Re: Nobscot Scout Reservation Trail Project
1 Nobscot Road, Sudbury, MA

Howard Stein Hudson (HSH) has prepared a response to the Sudbury Conservation Commission comments dated August 22, 2022 and offers the following responses including submitting supplemental information:

SITE PLAN FOR NOBSCOT SCOUT RESERVATION TRAIL PROJECT SUDBURY AND FRAMINGHAM, MA.

NOBSCOT SCOUT RESERVATION PERMITTING & CONSTRUCTION PLANS						
HSH PROJECT NUMBER	DATE	DRAWN BY	CHKD. BY	APPRVD. BY	SHEET NO.	TOTAL SHEETS
2016033.02	10/24/22	JBC	JD	REL	9	22

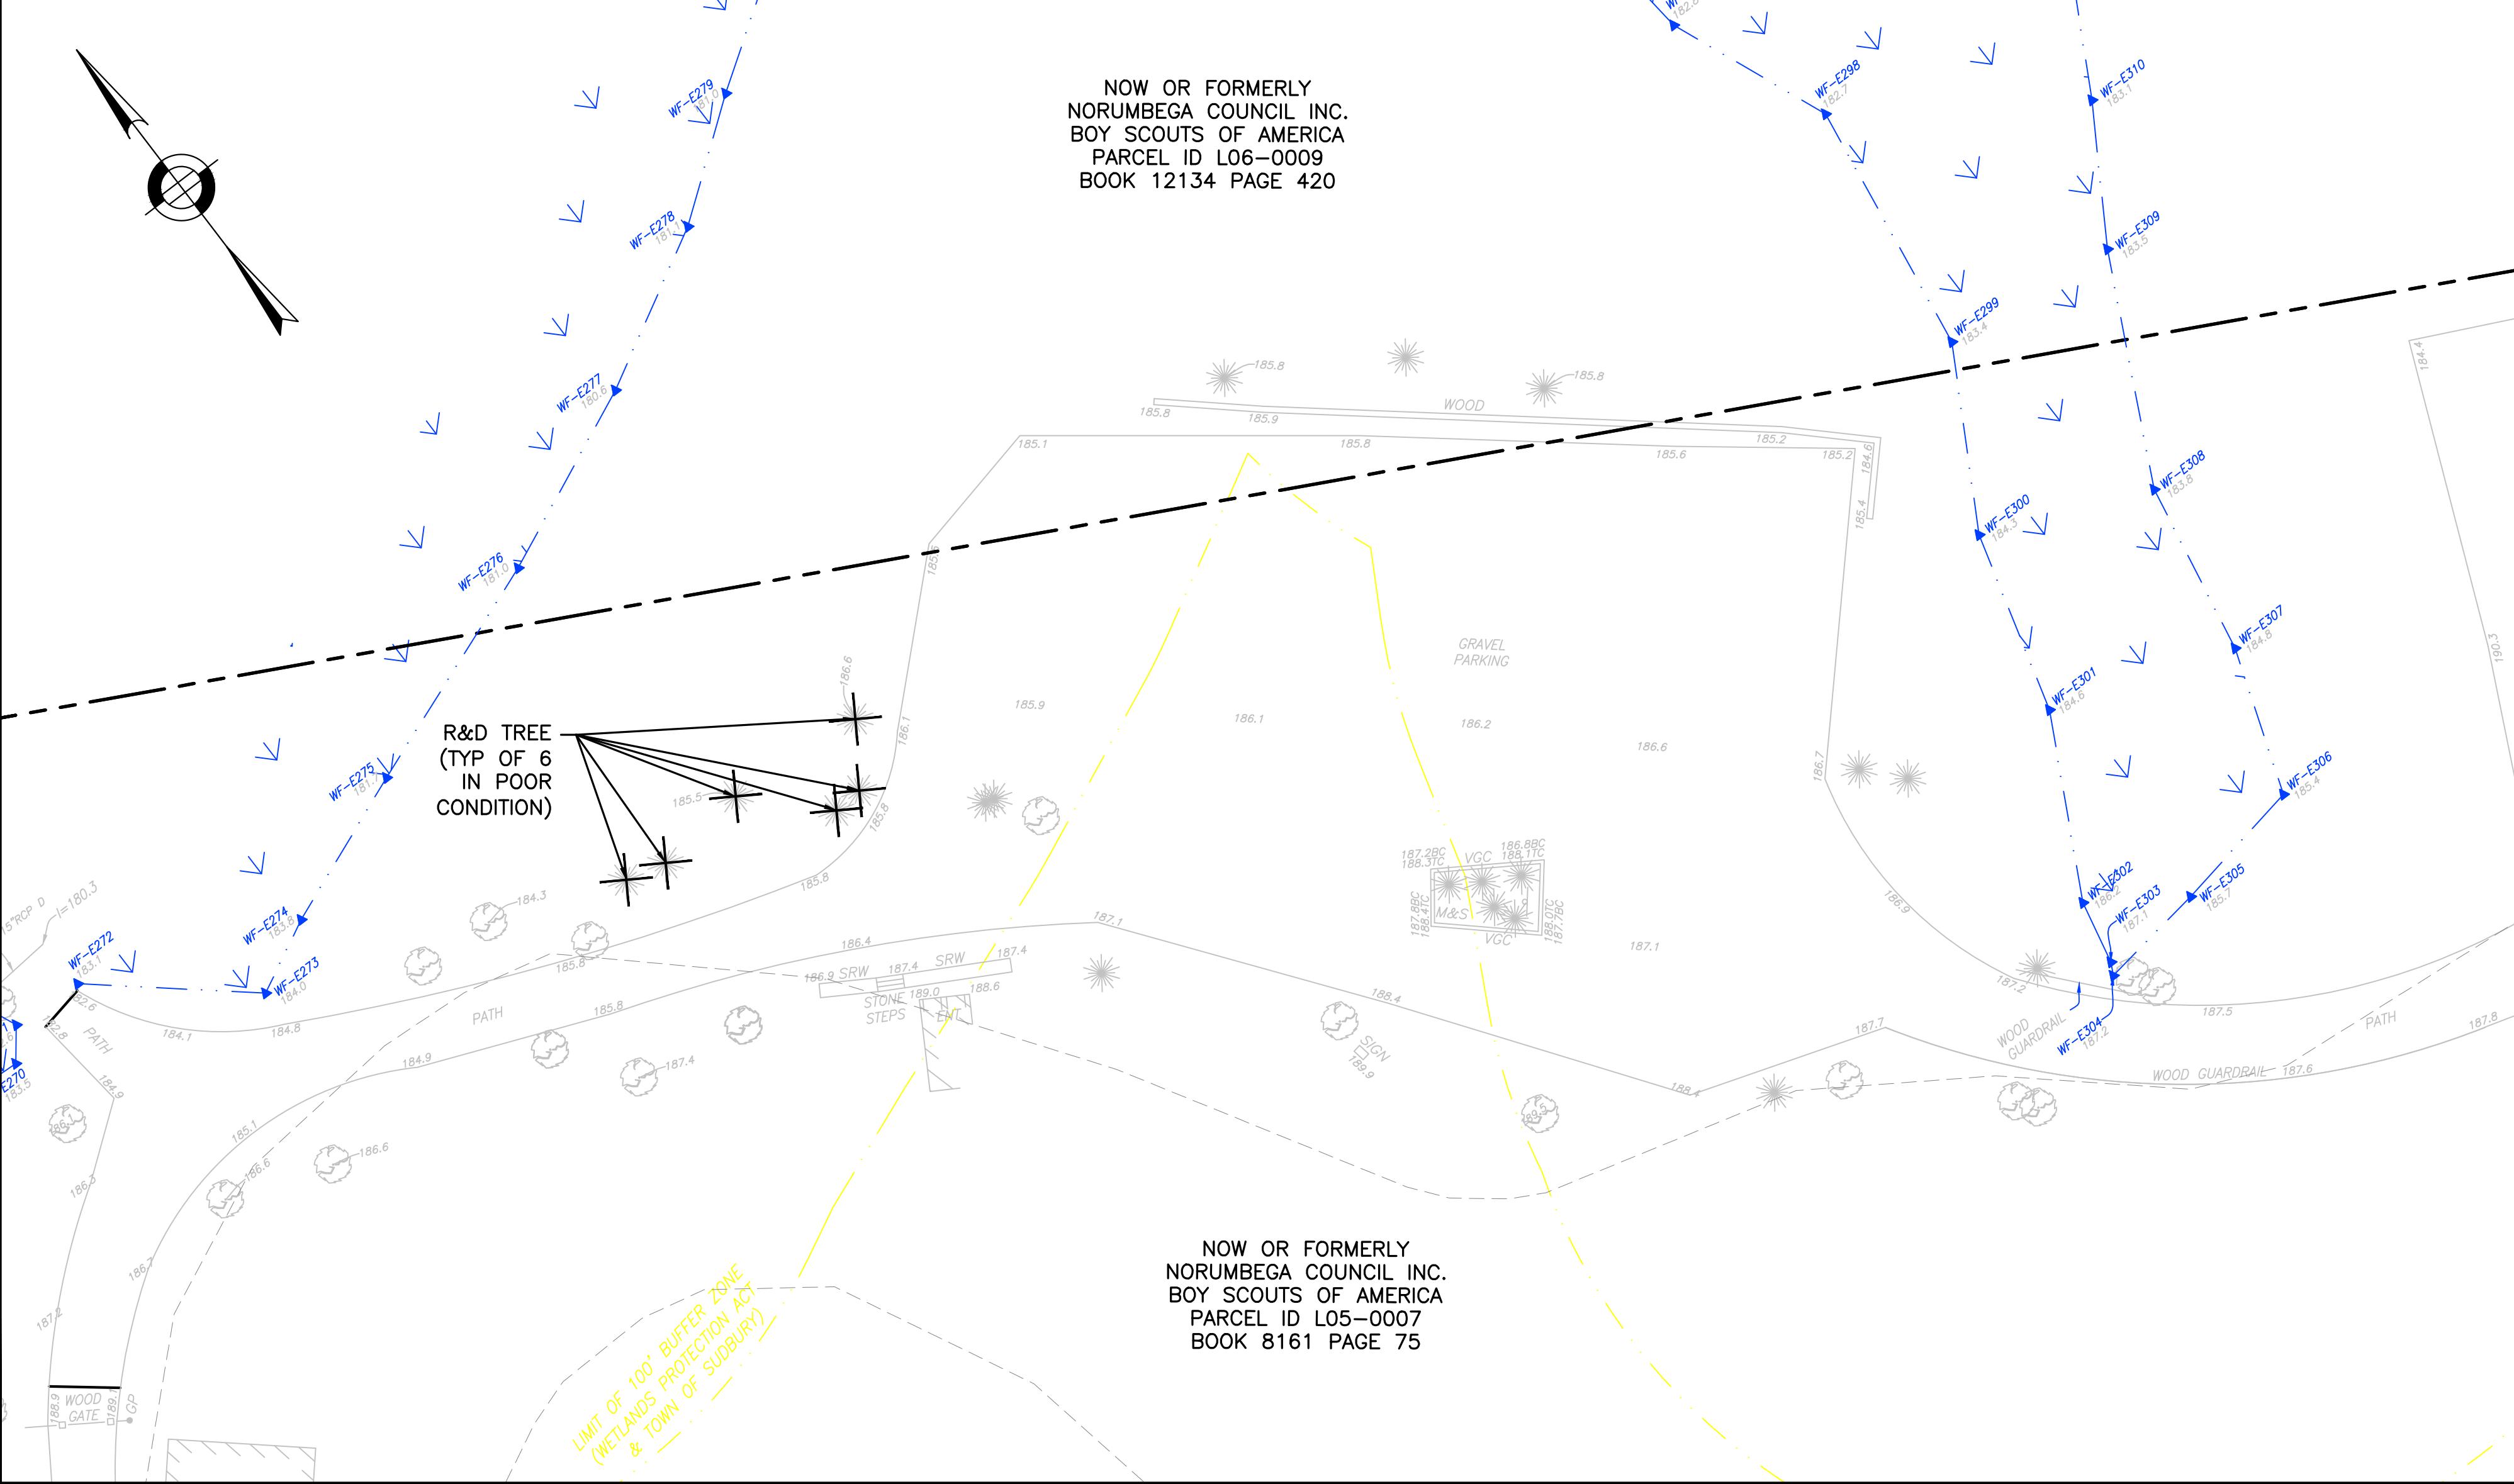
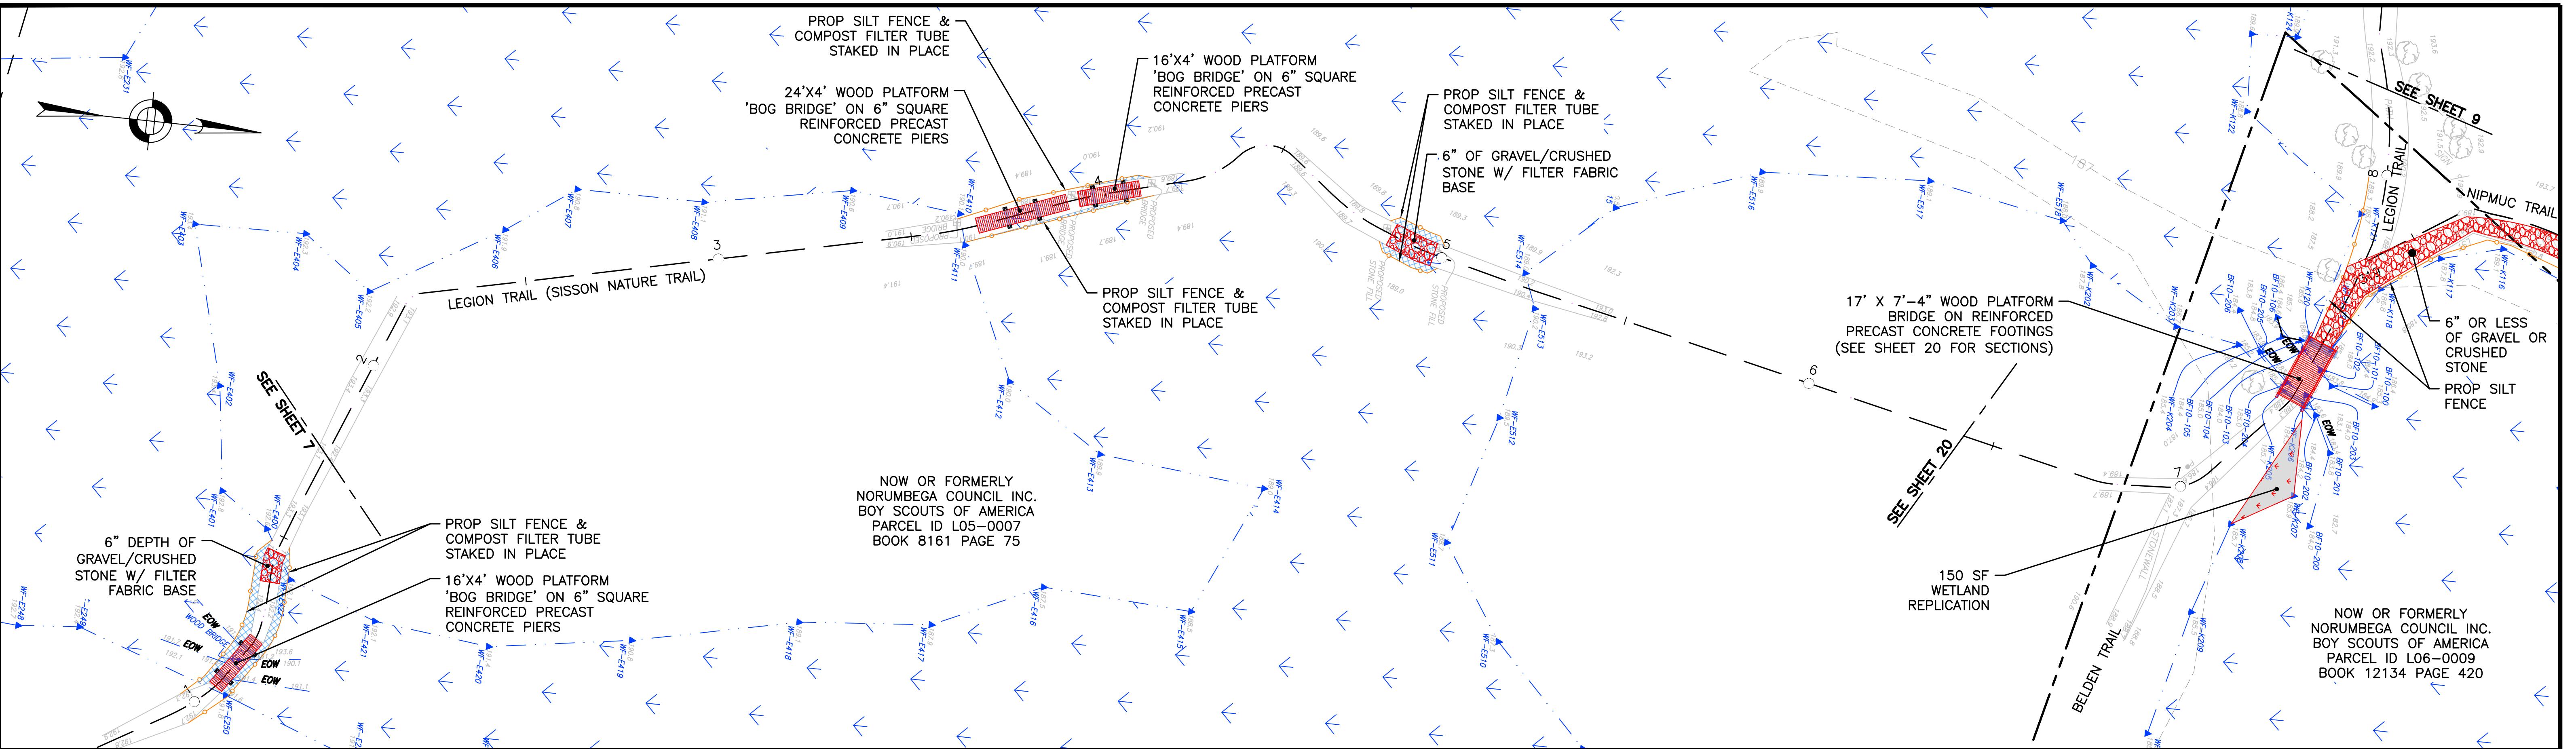
Comment 11: *Sheet 9 shows proposed fill within the wetlands as a temporary alteration. The applicant should explain how this is temporary. This area is also being widened to 18 feet at the widest point. The applicant should explain why this is expansion is needed.*

Comment 12: *Trail work at the boundary between Sheets 8 and 9 shown on the plan sheet above has no erosion controls and results in wetland fill. The applicant should explain if this area of trail could be moved to prevent this fill.*

Response: **If there is more than a 12-inch change in grade it is been classifying as a permanent impact and a wetland replicated is being provided. When the change in grade is less than 12-inches it is been classified as a temporary impact. This temporary impact area is still hydraulically connected to the wetland. This temporary impacted area will be loamed and hydroseeded with a wetland seed mix.**

Response: **This area has been redesign. There will be no filling of the wetland in this area. Ersion control measure have been added to the plan set on page 8 & 9.**
